Project: Proposed Interior Alterations along with Upgrades to Exterior Façades including New Dark-Sky Compliant Site Lighting & Upgraded Landscaping for ThermoDynamics Corp. – HVAC Contractor and Service Company
2989 Navajo Street, Yorktown Heights, NY 10598
Tax Assessor Section 6.18, Block No. 1, Lot No. 30
Owner: McBrothers Realty, LLC – Ryan McCormick, Member

Subject: Application for Site Plan Approval (Site Plan – Formal)

To: Planning Department
From: ABACA
Date: August 10, 2022
Subject: Thermo Dynamics Corp.
6.18-1-30; 2989 Navajo Street

Subject: Application for ABACA Approval
(Revised Drawings dated 08/11/22 incorporating ABACA Recommendations)

4 (TYP.) ROOF TRANSITION DETAIL
SCALE: 1-1/2" = 1'-0"

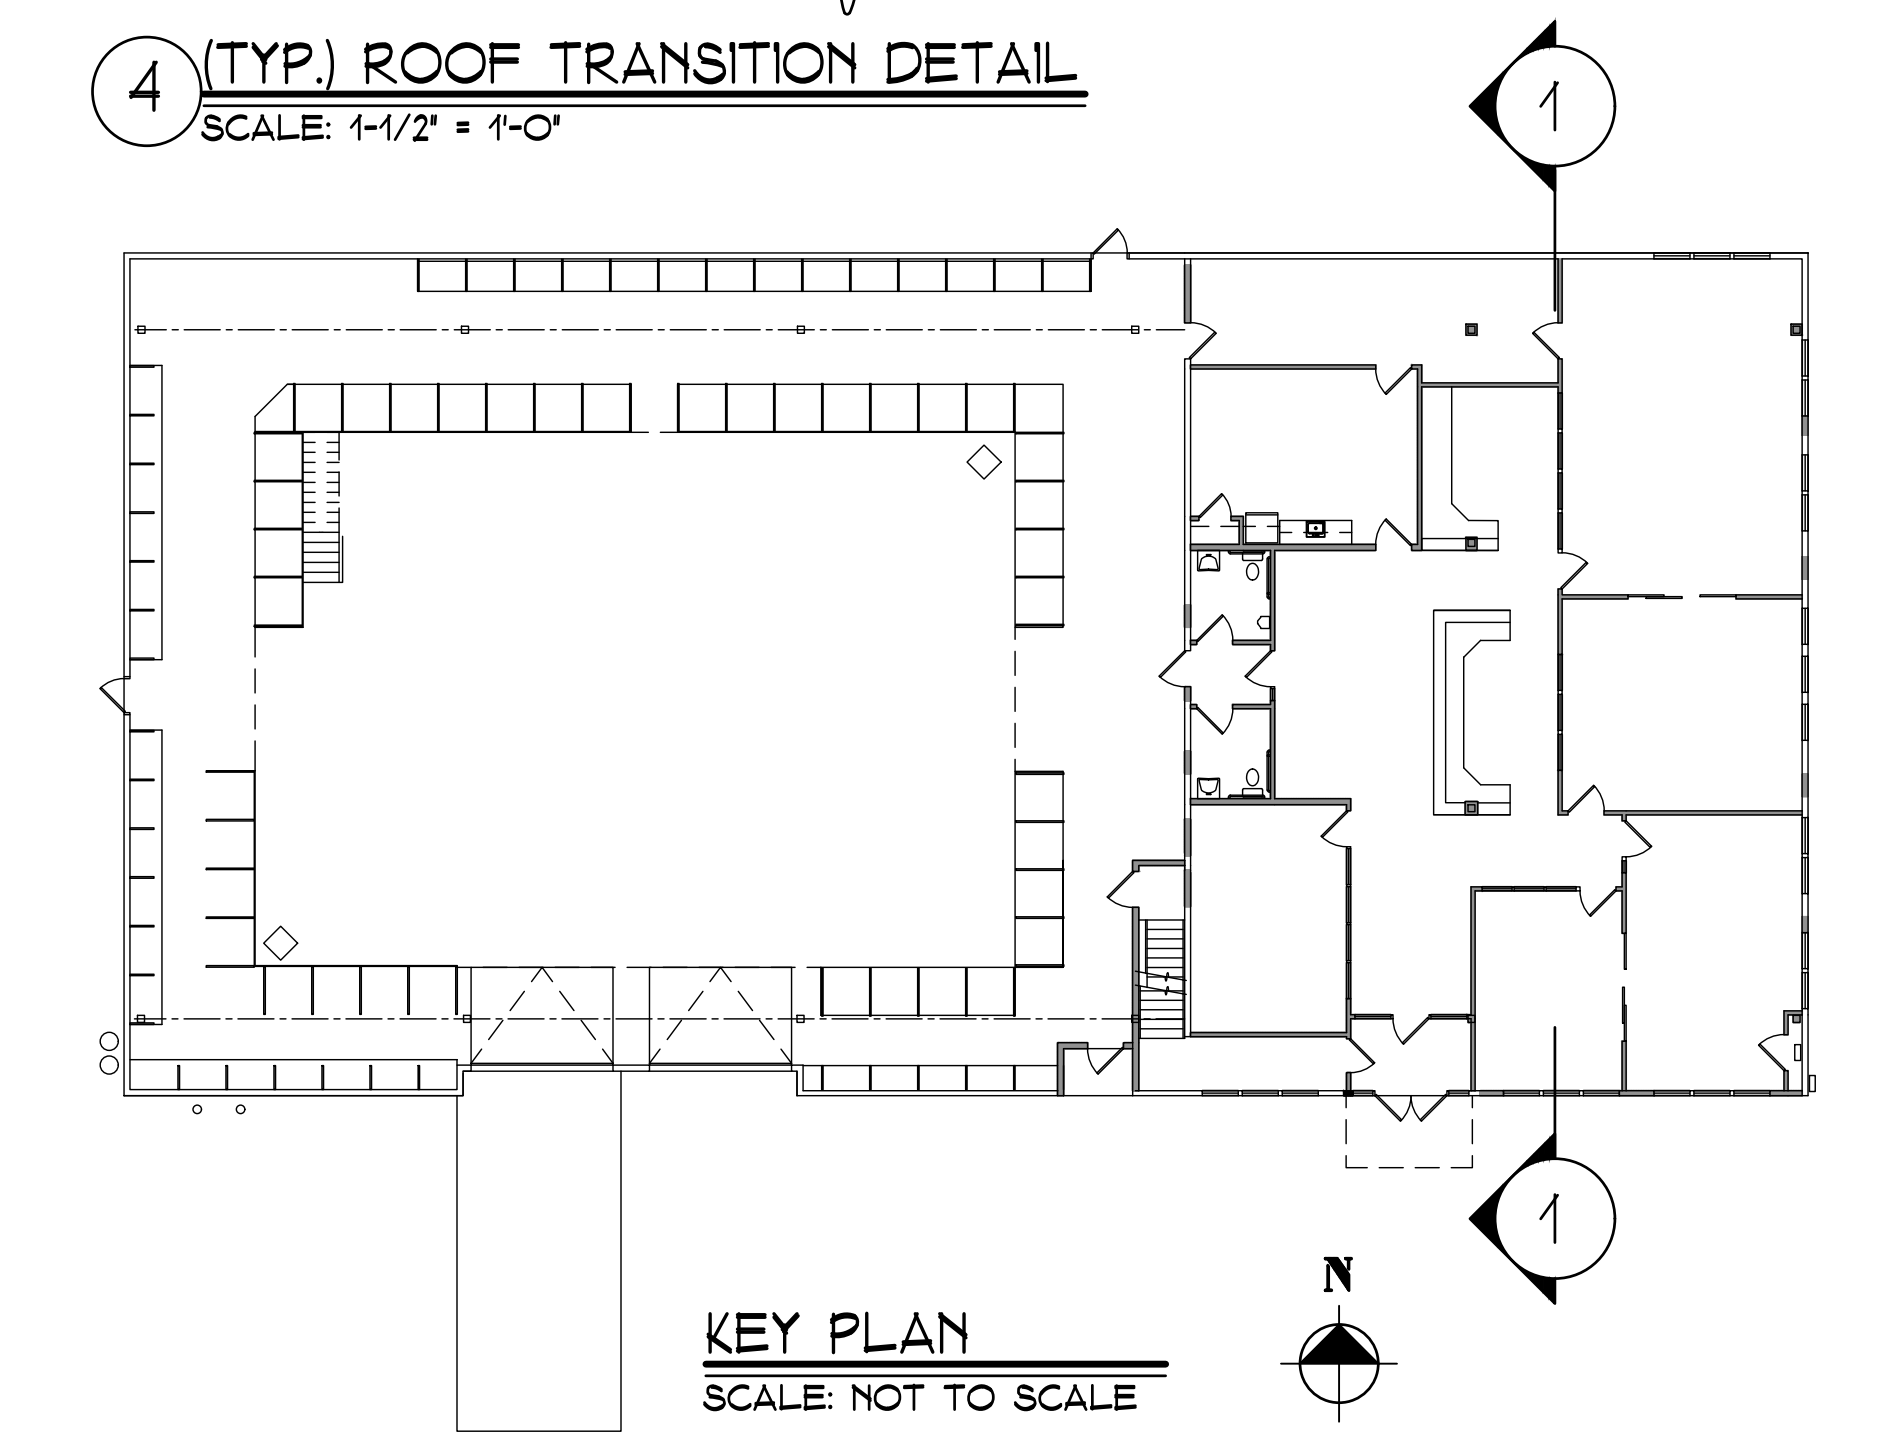
1. **Metal Roofing Detail** – One of the Members of the Board requested that we provide a Detail indicating the transition between the new Architectural style asphalt roof shingles and the standing seam metal roof. We have reviewed this condition with the Manufacturer of the metal roofing and have included a Detail on Drawing A-3, (Detail 4 entitled: Typical Roof Transition Detail).

FLASHING AT ASPHALT TO METAL ROOF TRANSITION. PROVIDE ZEE CLOSURE W/ BUTYL SEALANT AT STANDING SEAMS & WOOD BLOCKING AS REQUIRED. OVERLAP ASPHALT SHINGLES OVER FLASHING. (SEE ENLARGED TRANSITION DETAIL #4 ON THIS SHEET)
